**TOWN OF PORTOLA VALLEY
ARCHITECTURAL AND SITE CONTROL COMMISSION (ASCC)
Monday, January 28, 2013
7:30 PM – Regular ASCC Meeting
Historic Schoolhouse
765 Portola Road, Portola Valley, CA 94028**

TO: ASCC
FROM: Tom Vlasic, Town Planner
DATE: January 23, 2013
RE: Agenda for January 28, 2013 ASCC Meeting

4a. CONTINUED REVIEW FOR COMPLIANCE WITH CONDITIONS OF CONDITIONAL USE PERMIT (CUP) X7D-169, GREENHOUSE/POOL, GUEST HOUSE AND ART STUDIO, AND CONCURRENCE WITH SUBCOMMITTEE RECOMMENDATIONS RELATIVE TO PLANTING ISSUES, 555 PORTOLA ROAD, NEELY/MYERS

Site Plan, Figure 1

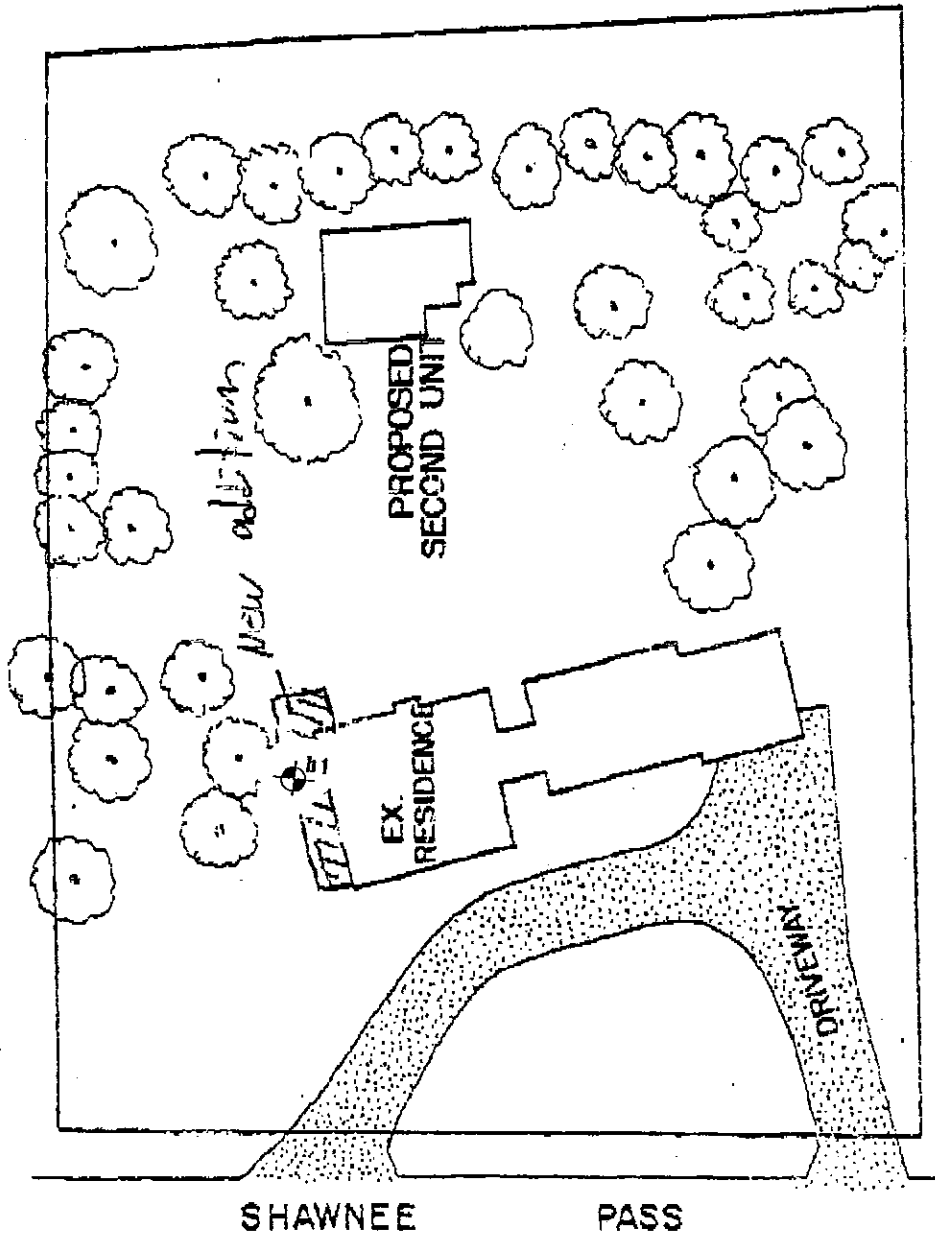
WTAI conducted the field investigation on June 7, 2005. The field investigation consisted of a site reconnaissance by the Project Engineer and an excavation of one exploratory boring. The boring were excavated using a minuteman drill-rig with 3.5-inch stem augers. The approximate location of the boring is shown on the Site Plan, Figure 1.
